IDAP REPORT

Property:	20 Wentworth Street GREENACRE LOT 4 DP 36122 DA2021.151
Proposal:	Demolition of existing structures and construction of a dual occupancy with basement.
Applicant:	ZTA Group
Owner:	R Ibrahim & J Ibrahim
Date of lodgement:	5 July 2021
Notification period:	13 July 2021 – 27 July 2021
Submissions received:	1
Assessment officer:	G I Choice
Estimated cost of works:	\$992,903.00
Zoning:	R2-Low Density Residential - SLEP 2012
Heritage:	No
Flood affected:	Yes
Is a Clause 4.6 Variation Proposed:	No
RECOMMENDATION OF OFFICER:	REFUSAL

Figure 2: Proposed basement plan

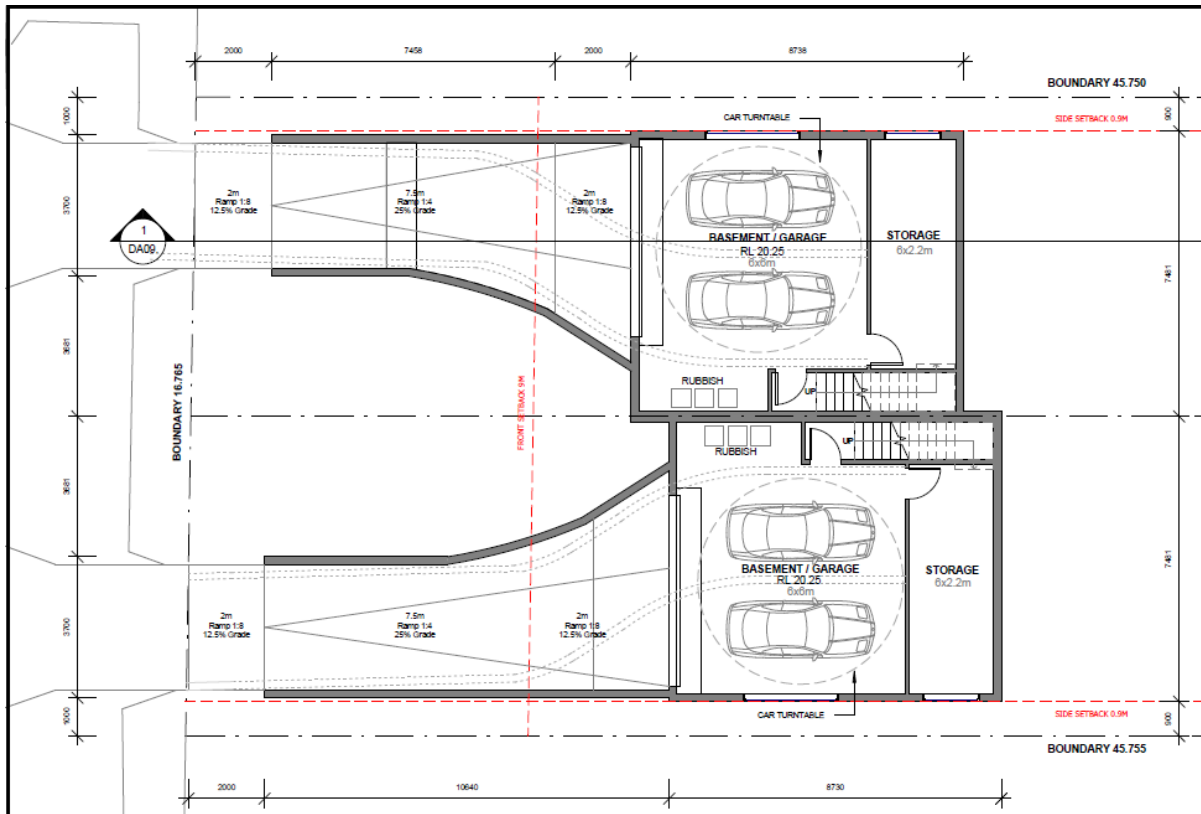
- ii. The basement protrusion of 1.65m above natural ground level was not supported as it is considered to adversely impact the bulk and scale of the dwelling.

- vi. Amended basement plans were required to demonstrate that all vehicles can enter and exit the site safely in a forward direction; and B85 vehicle swept paths were required to demonstrate all parking spaces are adequately accessible

Solid Component:	0.9m	1.2m	No – see discussion
Vehicle Access and Parking			
Driveway width at Boundary:	3m	3m	Yes
No. of Parking Spaces:	2 per dwelling	2 per dwelling	Yes
Basement:			
Basement protrusion:	Less than 1.0m	1.2m	No
Internal height:	2.2m	Min 2.2m	Yes

The proposed development provides the minimum two (2) required parking spaces for each dwelling. Adequate vehicular access is provided through a basement turntable design which allows vehicles to enter and exit in a forward direction and a minimum internal height of 2.2m is maintained. The basement protrudes to 1.2m above natural ground level and does not adequately minimise the visual impacts to the streetscape as discussed elsewhere in this report, however the proposal is considered to generally satisfy this control.

Figure 6: Proposed north & south elevations

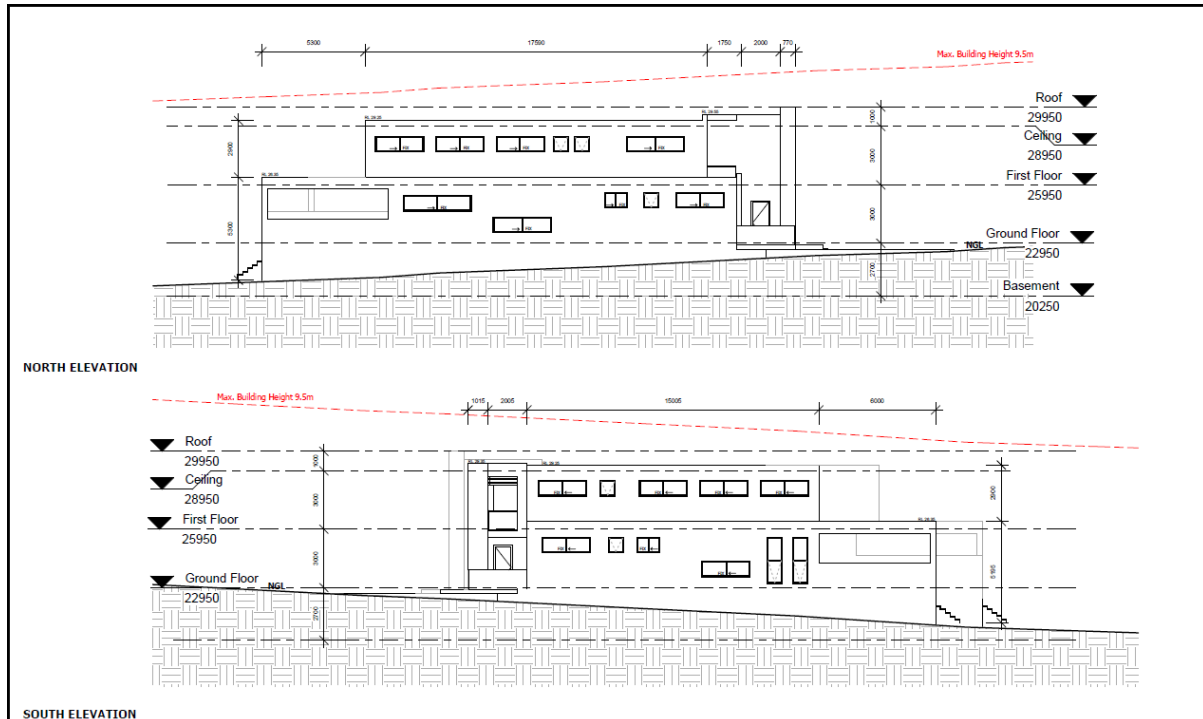
The protrusion of the proposed basement levels and subsequent raised upper floor levels contributes to a flat roof building height of 8m which is marginally higher than the typical 7.8m maximum height for flat roof dwellings in the Strathfield R2 low density zone. The proposed parapet RL 30.4 will sit above the adjoining roof lines of 18 Wentworth Street (RL 30.12) and 22A (RL 28.00). Further, the basement protrusion will result in a more visible basement garage entrance that will likely dominate the street frontage. Bulk and massing is further exacerbated by large first floor voids above the entry foyer of each new dwelling and deficient side setbacks of 900mm which result in an unreasonable breach of the north-south **45° building envelope. An improved internal design with better circulation on the first floor could remedy these impacts.**

The protrusion of the basement level above NGL, raised upper floor levels and proposed ground floor to ceiling height of 3.25m will result in ground floor external wall heights exceeding 4m on either side boundary. It is considered minimum 1.5m side setbacks are more appropriate than the proposed 900mm to reduce the visual impacts of bulk and massing on streetscape and adjoining properties. Further, increased setbacks would allow greater deep soil landscaping and potentially increase solar access to 22a Wentworth Street.

Part B of SCDCP 2005 requires walls along boundary setbacks to be broken or staggered to avoid the appearance of appearing unduly massive or long walls. No section of wall built on a side or rear boundary setback should be longer than 10 metres or 40% of the length of the boundary, whichever is the lesser. As shown in the DCP table above, proposed ground floor and first floor wall lengths are 20.4m and 17.6m (Dwelling A); and 18.2m and 15m (Dwelling B) respectively. Based on a merit assessment of the proposed development with regard to overshadowing and privacy issues, it is considered the proposal does not provide adequate treatments to avoid the appearance of unduly massive or long walls or minimise impacts as mentioned.

An assessment of the shadow diagrams shows that solar access to private open space at 22A Wentworth Street is achieved for a minimum period of 3 hours between 9.00am-3:00pm at the winter solstice. The protrusion of the basement and additional building height, coupled with reduced setbacks and poor articulation on side boundaries contributes to additional overshadowing of the adjoining southern property.

Figure 7: Proposed east & west elevations

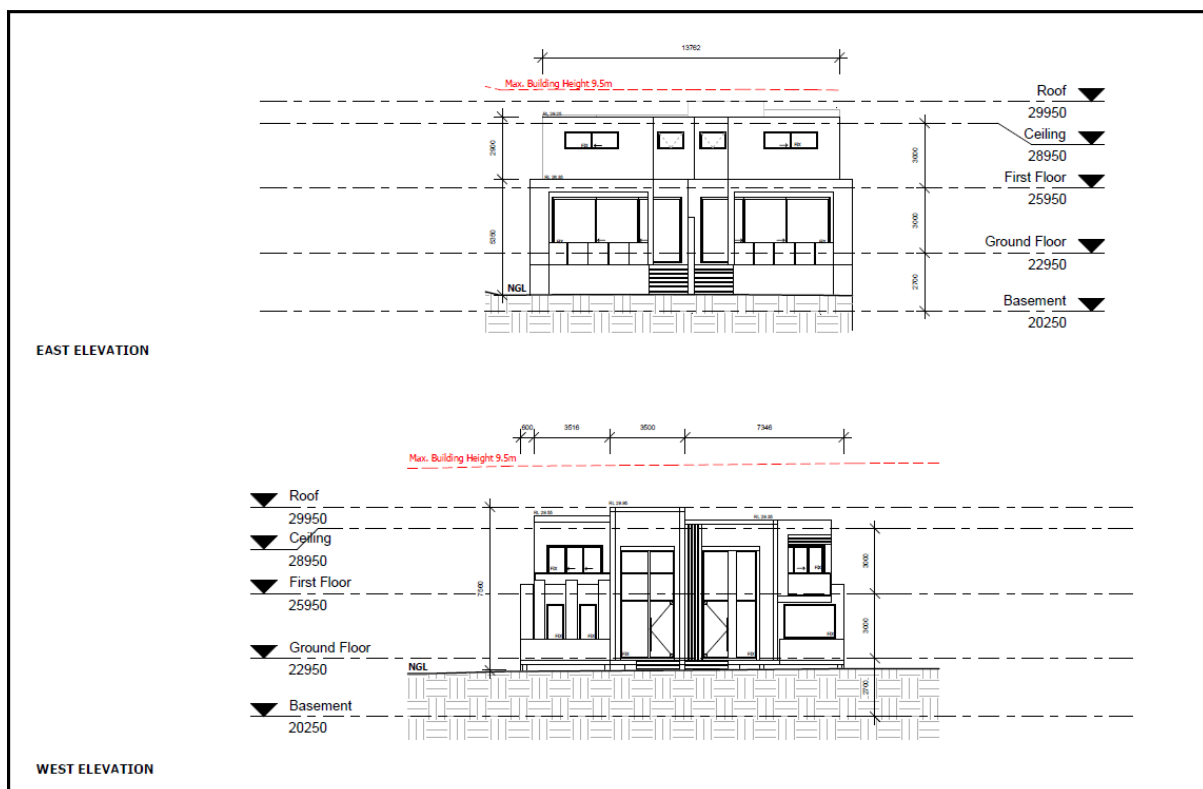
The raised rear alfresco areas at an RL 22.85 (AHD) result in 1.85m viewing platforms and will result in significant impacts to the visual privacy of adjoining properties. It is noted that alfresco areas are raised above the kitchen/living areas of each proposed dwelling (RL 22.5). Privacy screening could be applied to the open areas of alfresco side walls and rear, however it is considered this would reduce fenestration and further contribute to the overall bulky appearance of the side elevations.
